DART SERVICE INSTRUCTION

TO AMEND INSTALLATION INSTRUCTIONS D206-540 REV. J

THIS DART SERVICE INSTRUCTION PROVIDES PARTS AND INSTRUCTIONS FOR MODIFYING A D206-540-013 HELI-UTILITY-BASKET FOR INSTALLATION OF SCANNING EQUIPMENT.

A	SHT 2 BOM ITEM 3 QTY WAS 4	AJS	11.02.22
REV.	DESCRIPTION	BY	DATE
DESIGN	AJS	DART AEROSPACE LTD HAWKESBURY, ONTARIO, CANADA	
DRAWN	AJS		
CHECKED		DRAWING NO.	REV. A
MFG. APPR.		DSI 9542	SHEET 1 OF 4
APPROVED		TITLE	SCALE
DE APPR.		BASKET MODIFICATION	NTS
DATE	11.02.22	COPYRIGHT © 2011 BY DART AEROSPACE LTD <small>THIS DOCUMENT IS PRIVATE AND CONFIDENTIAL AND IS SUPPLIED ON THE EXPRESS CONDITION THAT IT IS NOT TO BE USED FOR ANY PURPOSE OR COPIED OR COMMUNICATED TO ANY OTHER PERSON WITHOUT WRITTEN PERMISSION FROM DART AEROSPACE LTD.</small>

FIGURE 1: D206-540-013 HELI-UTILITY-BASKET SHOWN
(EXPANDED METAL SHOWN LOCALLY FOR CLARITY)

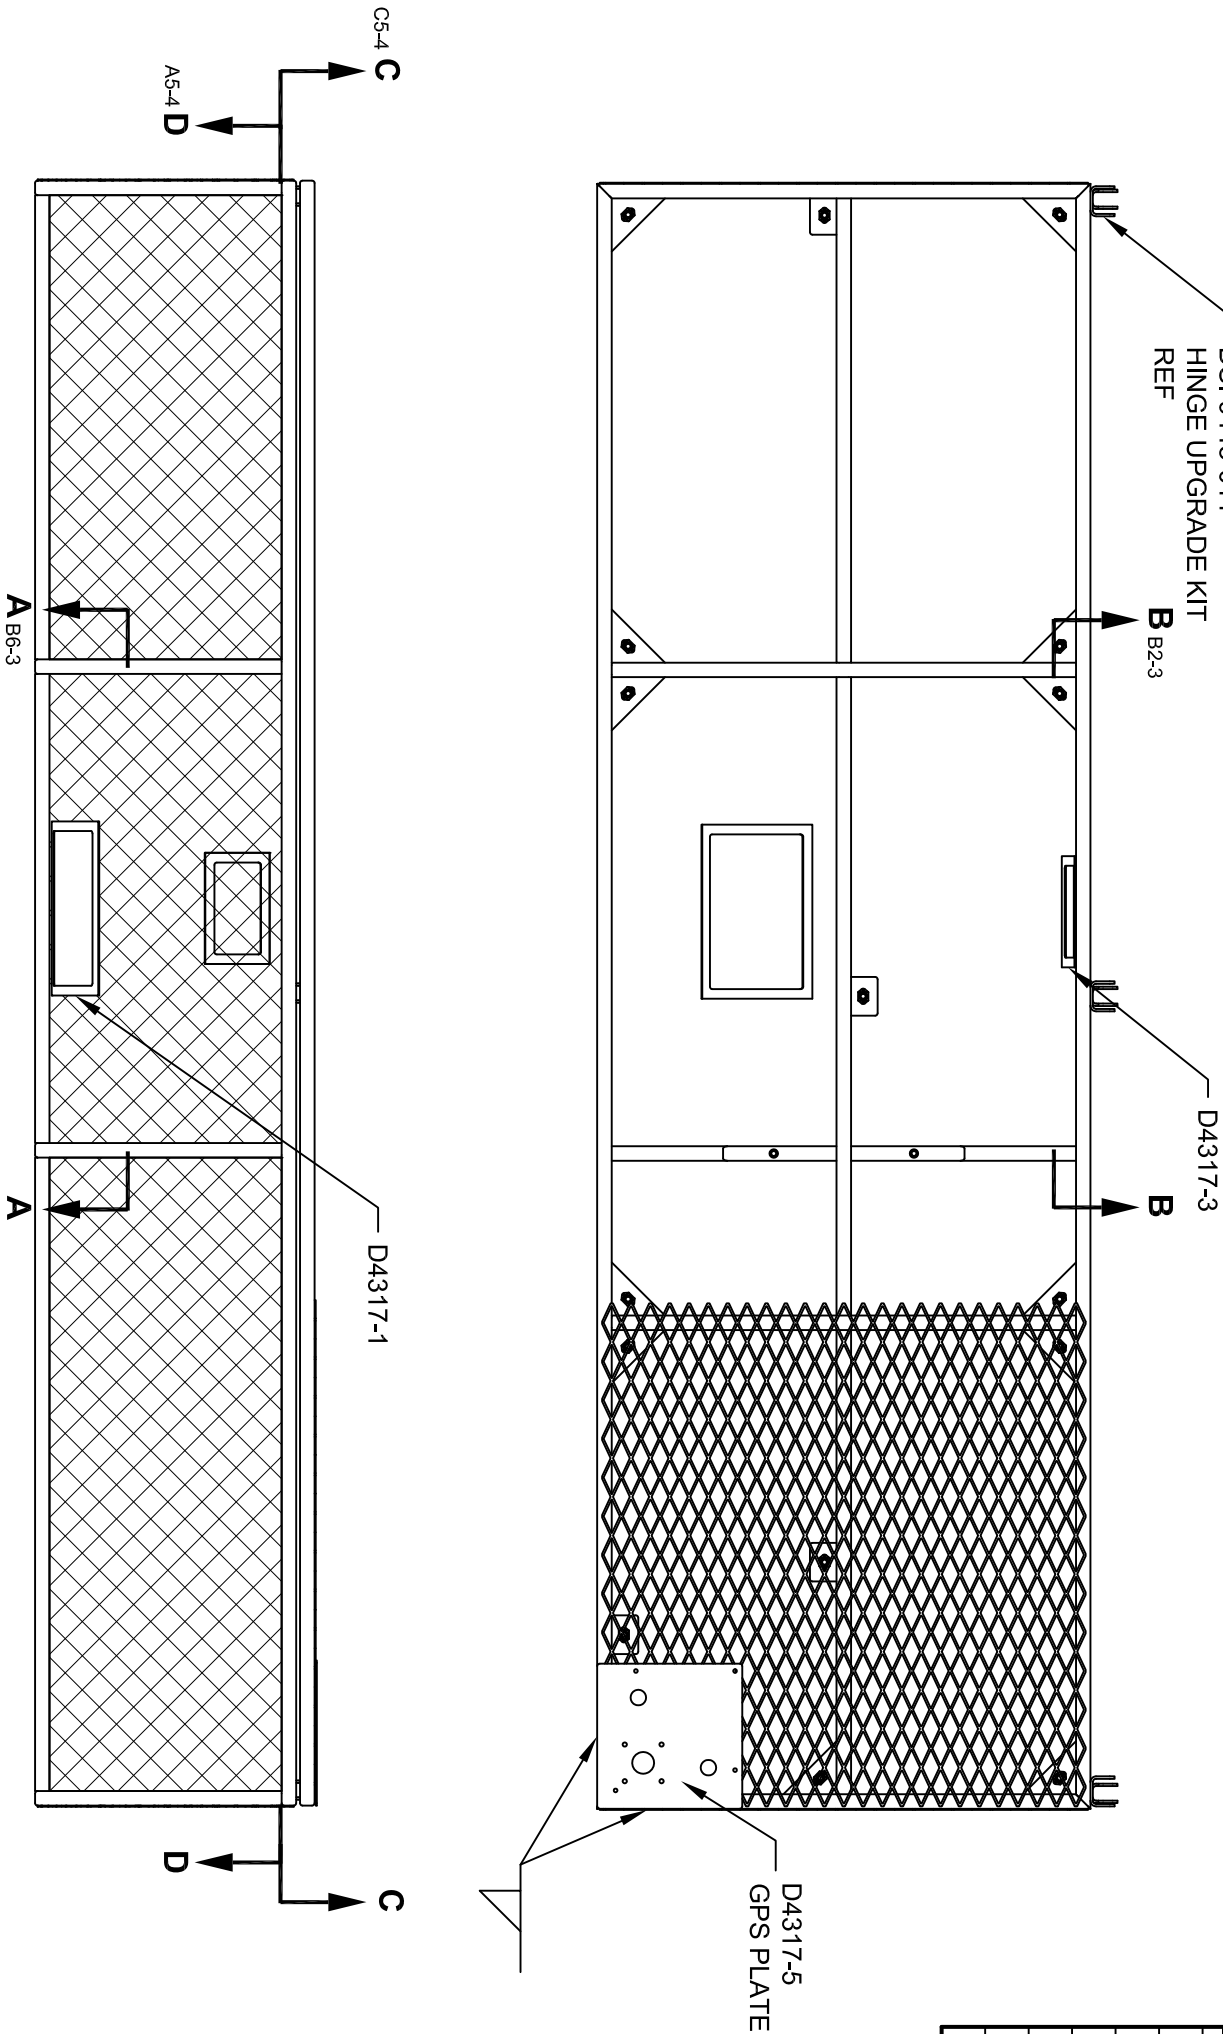
- 1) DISASSEMBLE BASKET AND RETAIN HARDWARE.
- 2) LOCATE THE D4317-1 VIEWING PLATE AND D4317-3 WIRING PLATE AND TRIM EXPANDED METAL AS SHOWN IN FIGURE 1 AND SECTIONS A-A & B-B. REMOVE FINISH ON EXPANDED METAL LOCALLY AND TIG WELD (TACK WELD) D4317-1 AND D4317-3 TO THE EXPANDED METAL, PER MIL-STD-2219/AMS-STD-2219 CLASS 'C' USING ER308L OR ER316L FILLER ROD.

- 3) LOCATE THE D4317-5 GPS PLATE AND TRIM EXPANDED METAL AS SHOWN IN SECTION C-C. REMOVE FINISH ON THE BASKET LID TUBULAR STRUCTURE AND EXPANDED METAL LOCALLY. TIG WELD (FILLET & TACK WELD) D4317-5 TO THE TUBULAR STRUCTURE AND EXPANDED METAL AS SHOWN IN FIGURE 1, PER MIL-STD-2219/AMS-STD-2219 CLASS 'C' USING ER308L OR ER316L FILLER ROD.

SECTION C-C

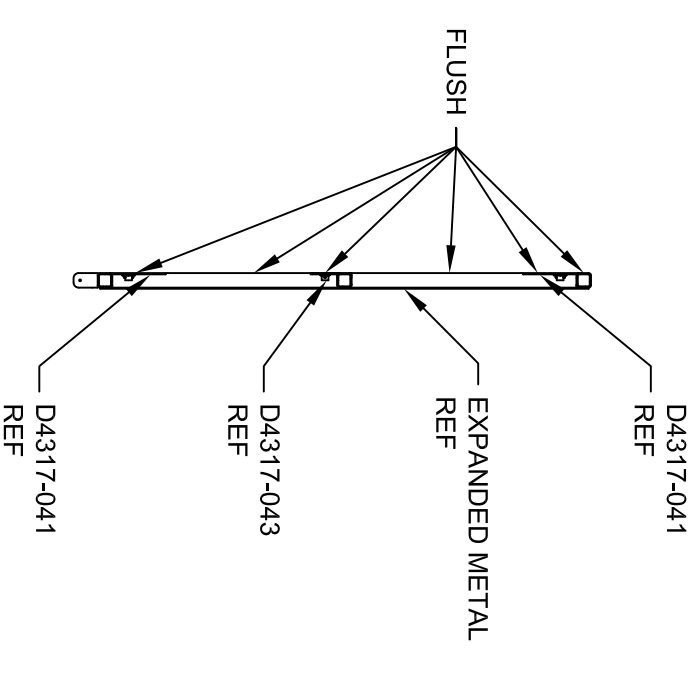
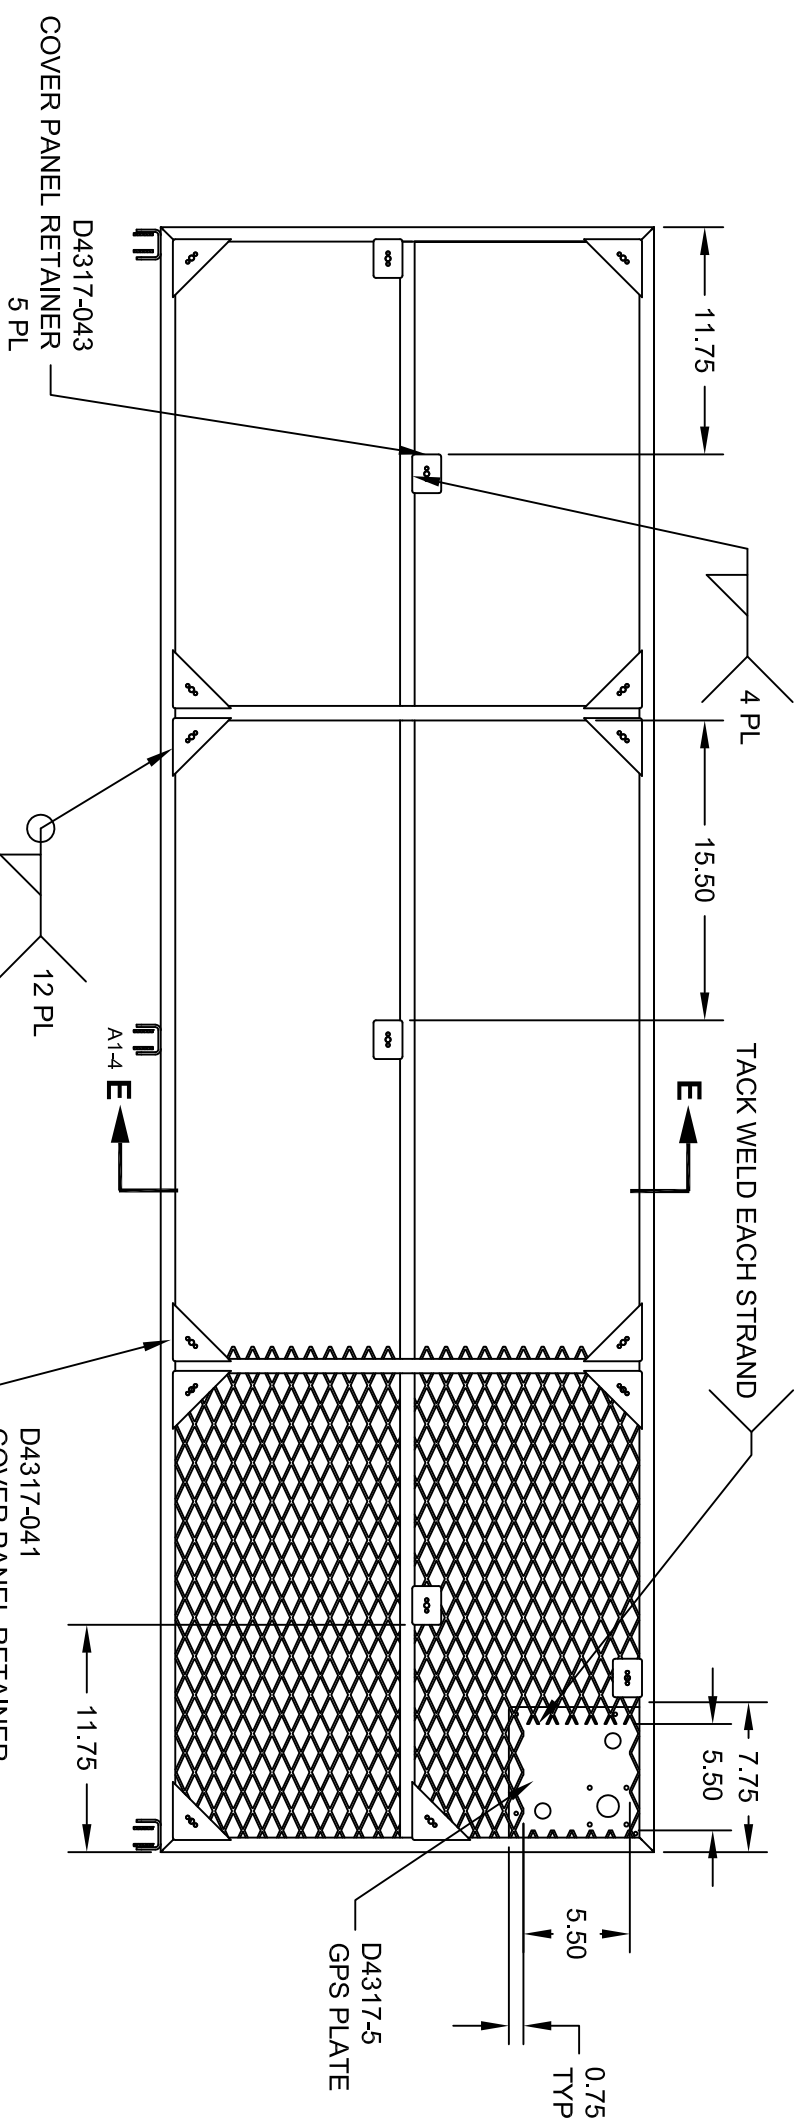
- 4) LOCATE D4317-041/-043 AS SHOWN IN SECTION C-C. REMOVE FINISH ON THE BASKET LID TUBES LOCALLY AND TIG WELD THE D4317-041/-043 COVER PANEL RETAINERS IN PLACE PER MIL-STD-2219/AMS-STD-2219 CLASS 'C' USING ER308L OR ER316L FILLER ROD.

SECTION D-D

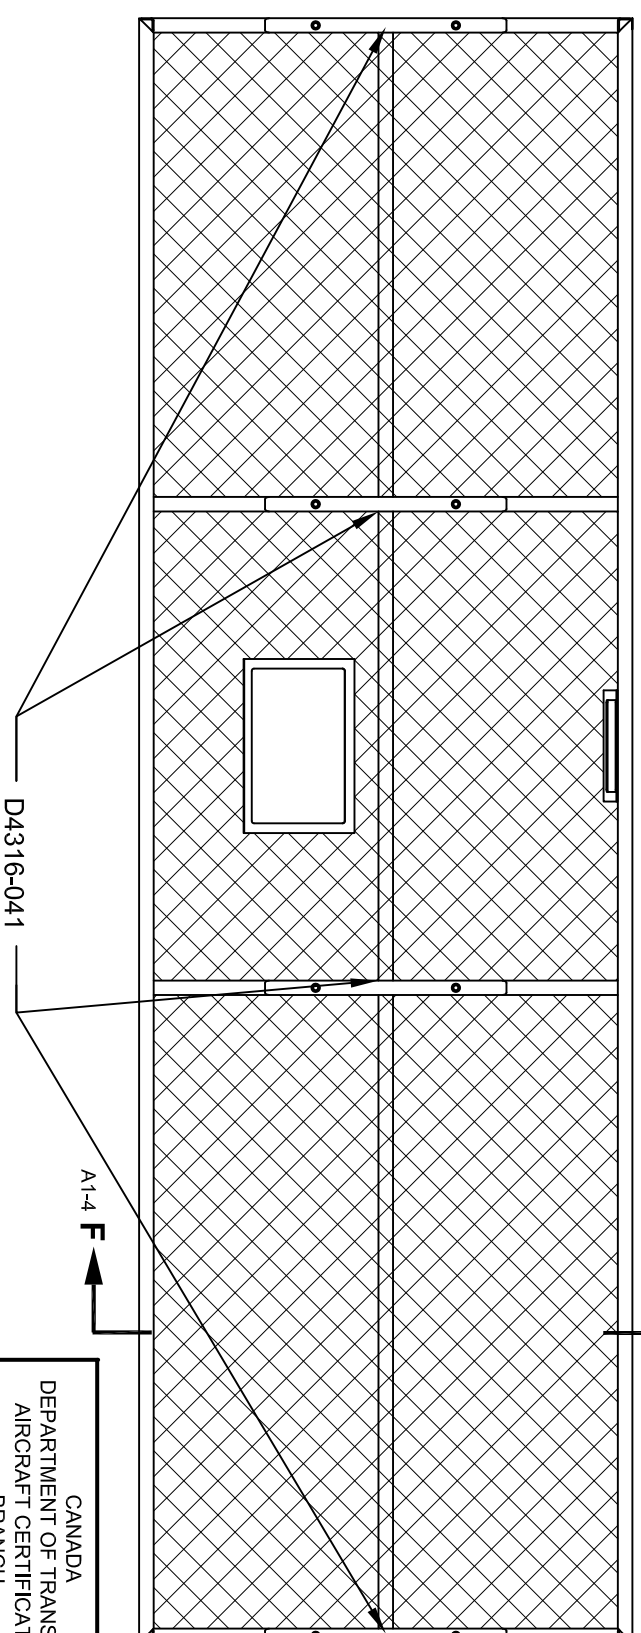
- 5) LOCATE QTY (4) D4136-041 TUBE ASSEMBLIES AS SHOWN IN SECTION D-D. REMOVE FINISH ON THE BASKET BASE HOOPS LOCALLY AND TIG WELD THE D4136-041 TUBE ASSEMBLIES IN PLACE PER MIL-STD-2219/AMS-STD-2219 CLASS 'C' USING ER308L OR ER316L FILLER ROD.
